Re: FPL Turkey Point Units 6 & 7 Project
Prevention of Significant Deterioration Draft Permit
Project No. 0250003-013-AC (PSD-FL-409)

Comments on Turkey Point Units 6 & 7 PSD Draft Permit and Technical Evaluation and Preliminary Determination

Re: FPL Turkey Point Units 6 & 7 Project
Request for Additional Information
Air Permit Application and Prevention of Significant Deterioration Analysis
Project No. 0250003-013-AC (PSD-FL-409)

Figure 2PSD-1-c
Time History of Salinity in Biscayne Bay near Turkey Point
Source: South Florida Water Management District, 2009.

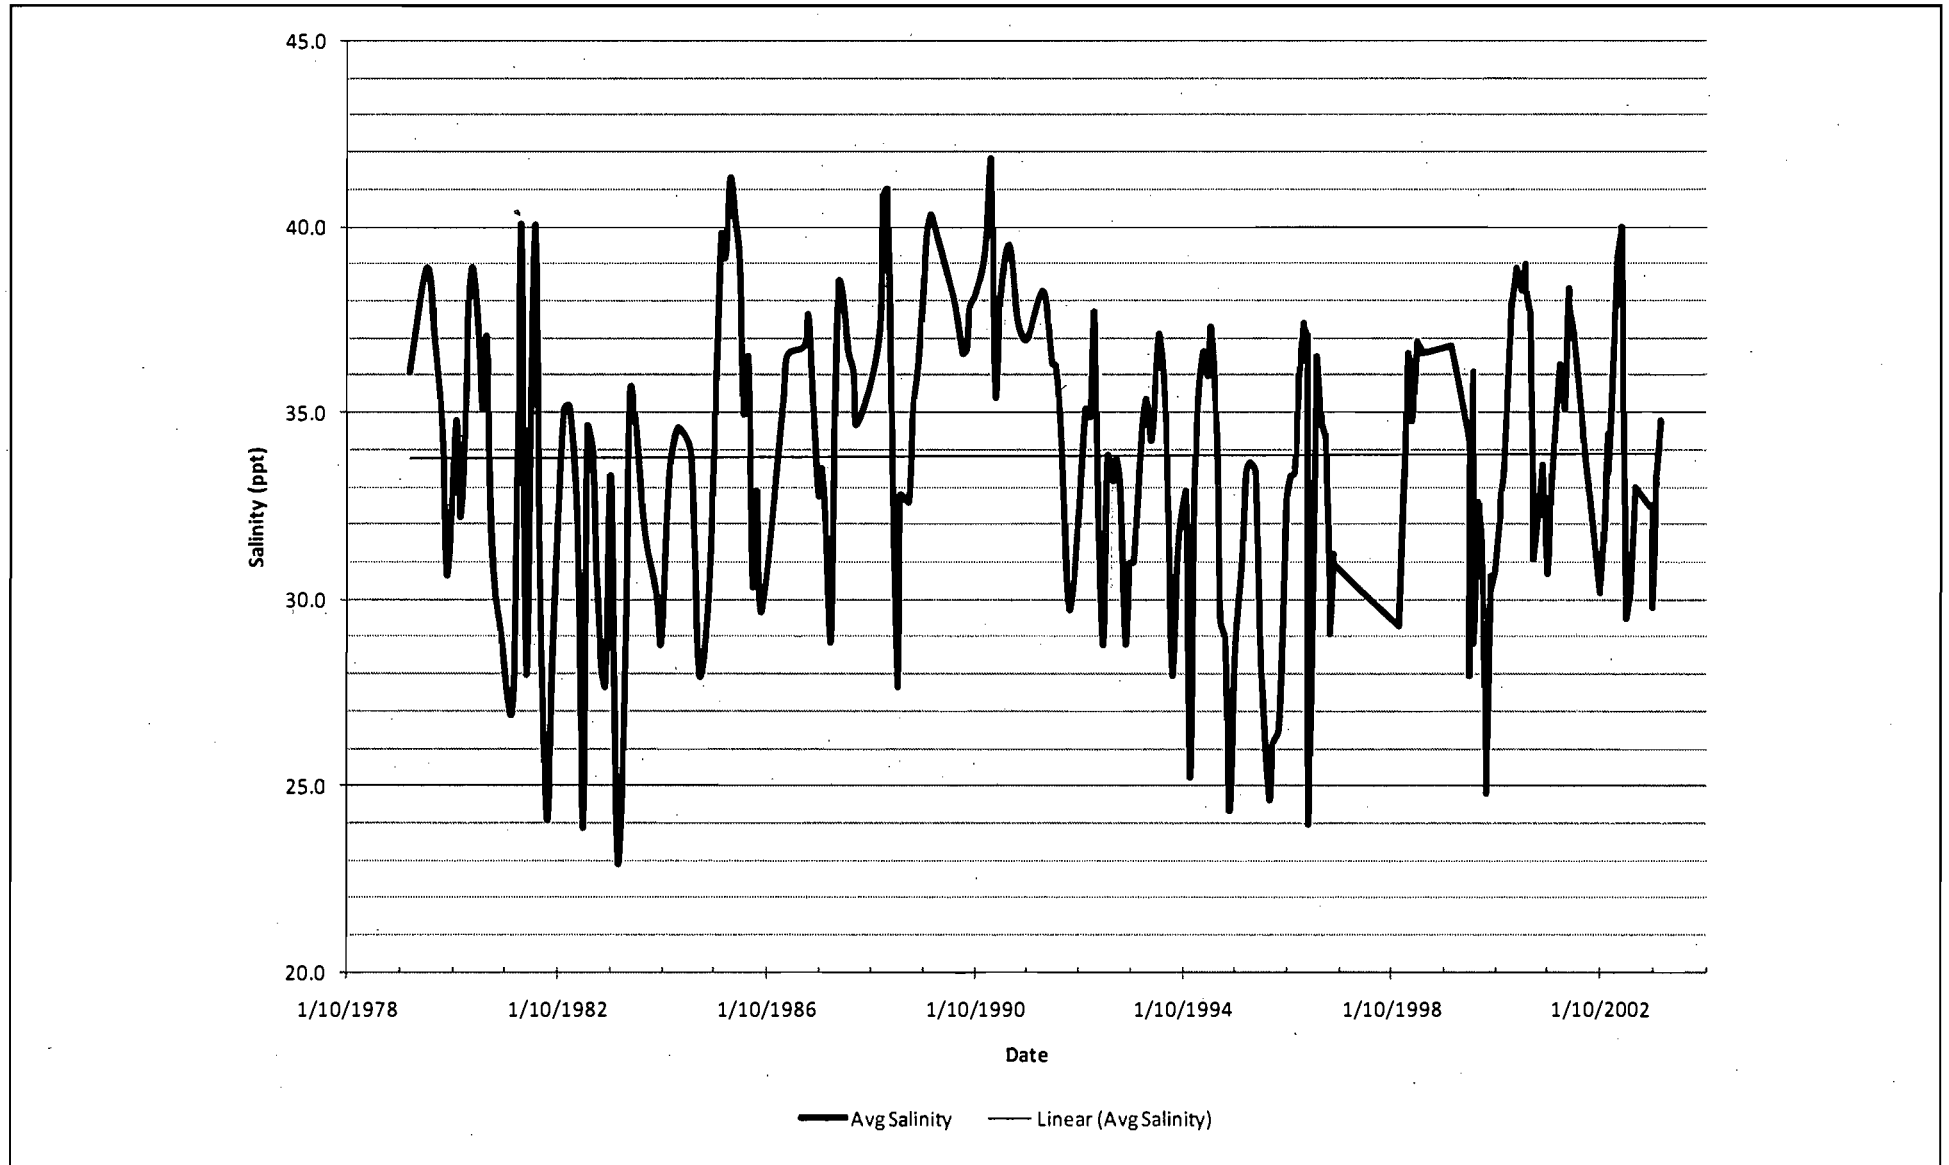
FDEP-2PSD-1-c The second source of water will be from radial collector wells, for which you estimate a maximum TDS concentration of 65,000 ppmw. In your response, you provided a representative analysis of the actual TDS for this source of water as 33,800 to 35,800 mg/L, which is approximately 33,800 to 35,800 ppmw. At this concentration, would the maximum total PM emissions from the cooling towers be reduced to approximately 518 tons/year?

The maximum estimated TDS concentration of 65,000 ppmw in the circulating water is based on the variability of TDS concentrations in Biscayne Bay and operation of the cooling towers. Although the water is withdrawn from 40 feet (ft) below Biscayne Bay via radial collector wells, the saltwater is expected to have TDS concentrations similar to those found in Biscayne Bay. The maximum TDS concentration of 65,000 ppmw for the circulating water is based on an upper bound of TDS concentration for saltwater of 43,333 ppmw from the radial collector wells, with 1.5 cycles of concentration.

Figure 2PSD-1-c shows the salinity in Biscayne Bay at a station near Turkey Point. Salinity is measured in parts per thousand (ppt) that approximates TDS concentrations in ppmw when multiplied by 1,000. The average salinity in Biscayne Bay near the Turkey Point peninsula is approximately 34 ppt or approximately 34,000 ppmw TDS. During wet periods, the salinity in the Bay is typically below average; during dry periods, the salinity in the Bay is typically above average. As shown in Figure 2PSD-1-c, the salinity can exceed 40,000 ppmw.
